STAFF REPORT

Case Number: 2022-ZON-112
Address: 7305 and 7725 Kentucky Avenue (*Approximate Address*)
Location: Decatur Township, Council District #20
Petitioner: Camby Village, LLC, by Brian J. Tuohy
Request: Rezoning of 123.23 acres from the C-4 and C-S districts to the C-S district to provide for all uses permitted in the I-1, I-2, C-3, D-4 and D-5II districts and an automobile fueling station.

Combined Conceptual

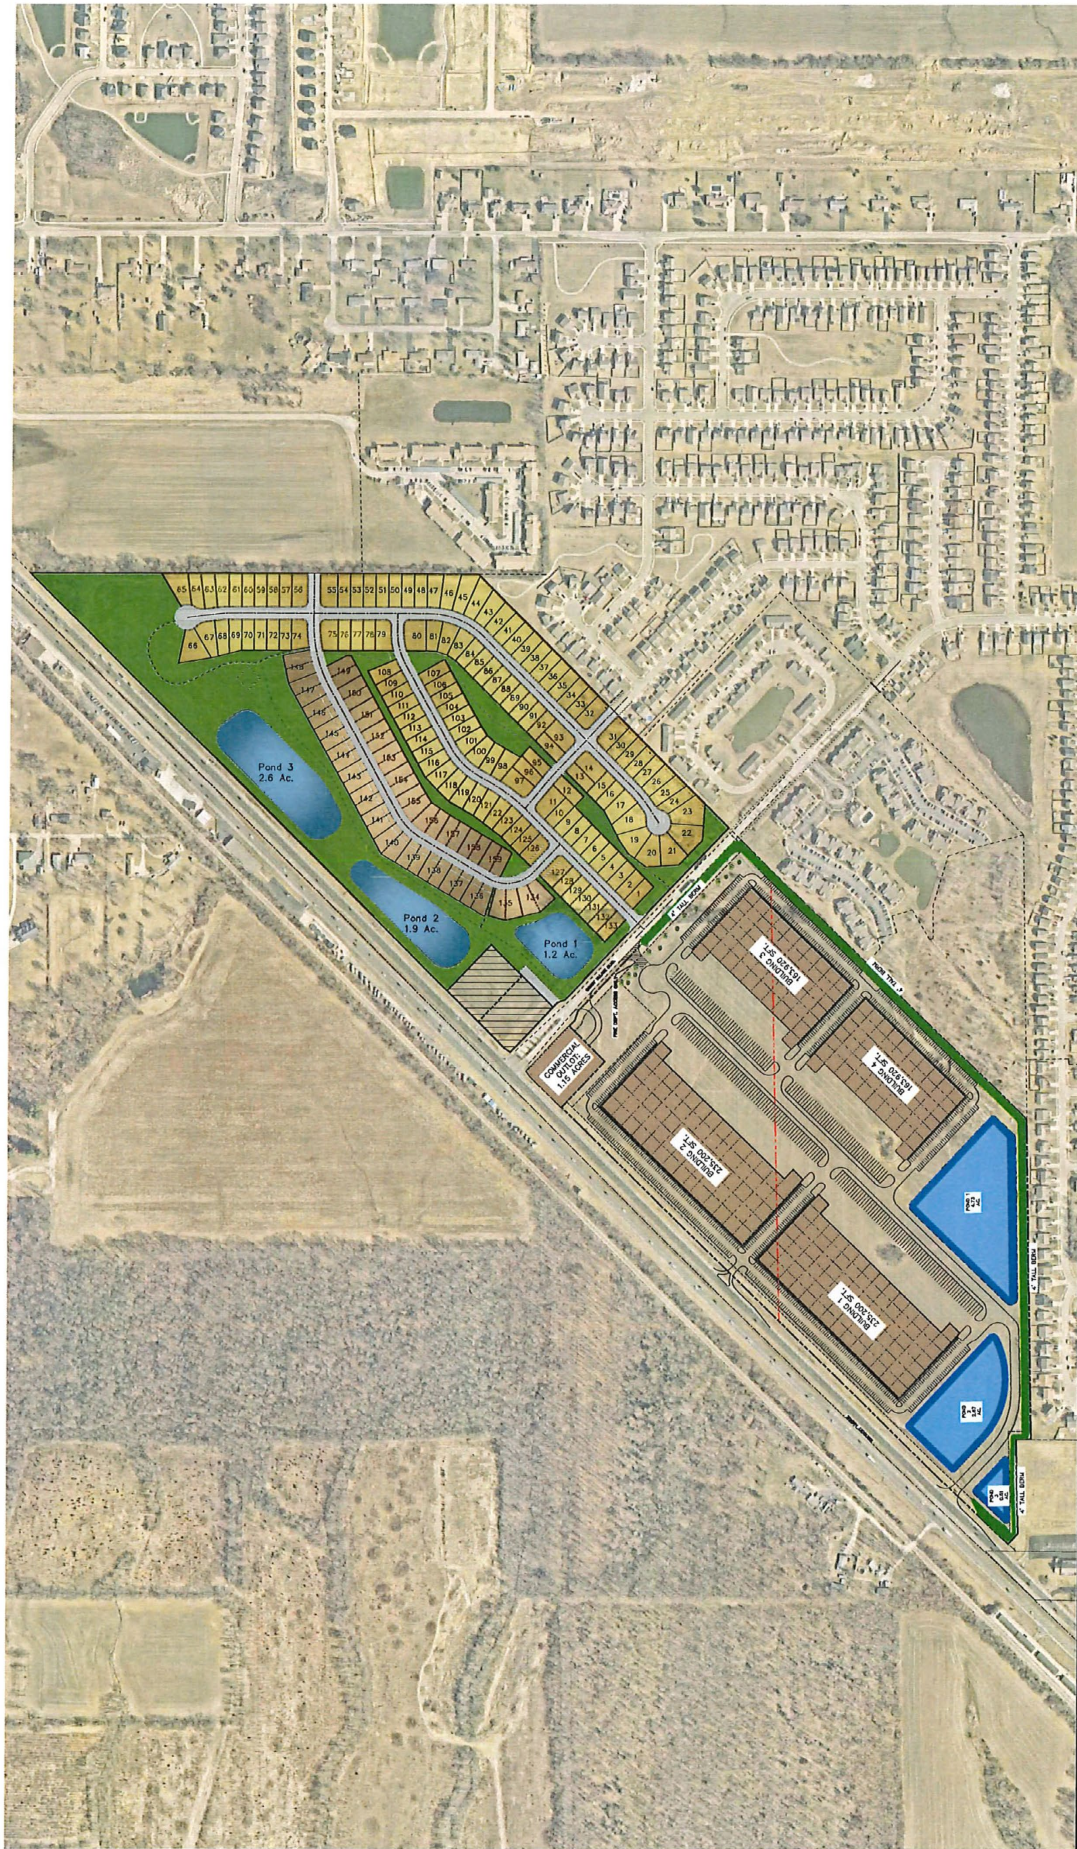
- ◇ The site plans, file-dated August 25, 2022, depict two options related to the layout of the industrial area that includes a three industrial building layout and a four industrial building layout. Staff understands the options provide the flexibility to respond to the future needs of potential users.
- ◇ Truck and employee access associated with the industrial development would be located at the southern end of the site along Kentucky Avenue. Access along Camby Village Boulevard would be limited to emergency access only to the industrial development.

- ◇ Truck and employee parking associated with the industrial development would be located interior to the site, with employee parking located on the perimeter on the buildings primarily along Kentucky Avenue and the eastern boundary abutting the existing multi-family development.
- ◇ Retention / detention ponds would be located throughout the development as determined by drainage requirements.
- ◇ A four-foot-tall landscape berm is depicted along the southern, eastern and a portion of the northern boundary of the industrial development, which abuts and would be adjacent to residential uses.
- ◇ The northern parcel would be developed with single-family and two-family dwellings. Access to the residential development would be along Camby Village Boulevard with a second access connecting to Firecrest Lane and a stub street to the north for a possible future connection.

- ◇ Staff, therefore, supports the proposed rezoning request, subject to enhanced buffering that would consist of a six-foot tall berm along those portions of the site where a four-foot-tall berm is proposed. Staff also believes that a double row of year around (evergreen) landscaping would be appropriate and provide some mitigation between the two land uses.

- ◇ Staff believes limiting access to the industrial portion of the site to the southernmost point further minimizes the impact of this use on surrounding land uses.

1. Industrial building elevations shall be submitted for Administrator Approval prior to the issuance of an Improvement Location Permit (ILP).
2. The berm, as depicted on the site plan, file-dated August 25, 2022, shall be six feet tall and landscaped with a double row of evergreen trees to provide year around screening.
3. An eight to ten-foot wide multi-use path shall be installed along the Kentucky Avenue frontage.
4. The site and improved areas within the site shall be maintained in a reasonably neat and orderly manner during and after development of the site with appropriate areas and containers / receptables provided for the proper disposal of trash and other waste.
